Change Notification #: 112912 - 00
Change Title: Intel® Server System R2308BB4GC
PCN 112912-00, Product Design
Update System PSU Bracket
Date of Publication: March 03, 2014

Intel is implementing the following change on Intel® Server System R2308BB4GC:

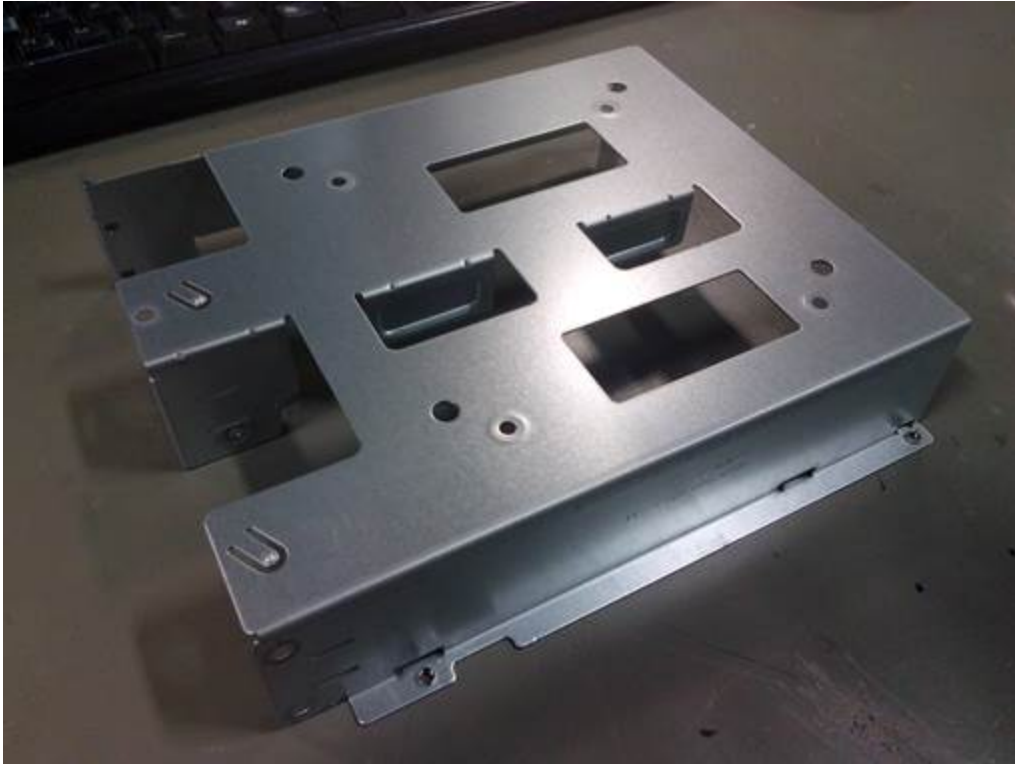
Update the Power Supply bracket by removing the middle punch. Please refer to the following pictures for details:

Pre-change:

Post-change:
